SLINGSBY AIRCRAFT COMPANY LTD., KIRKBYMOORSIDE, YORKSHIRE ENGLAND.

Technical Instruction No. 32 T.51 Darts which are outside the scope of Mandatory Modification No. 67

MANDATORY MODIFICATION No. 67A

ASSEMBLY OF FRICTION DEVICE. DART MOD 67A.

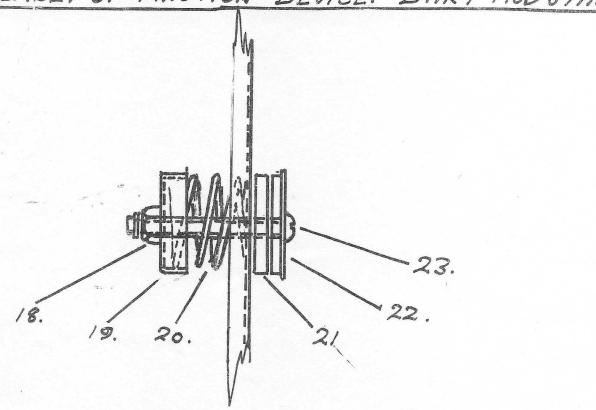
4. Fit items 18, 19, 20, 21, & 23 as supplied in Modification kit in accordance with sketch attached. Use existing large dia. 3/16 washer removed from old assembly.

Tension in accordance with rigging drawing 51-1-1 Iss. 6 or 7 or 51-1-201 Iss. 8 or 9 whichever is applicable. No grease whatsoever should be present on the friction device.
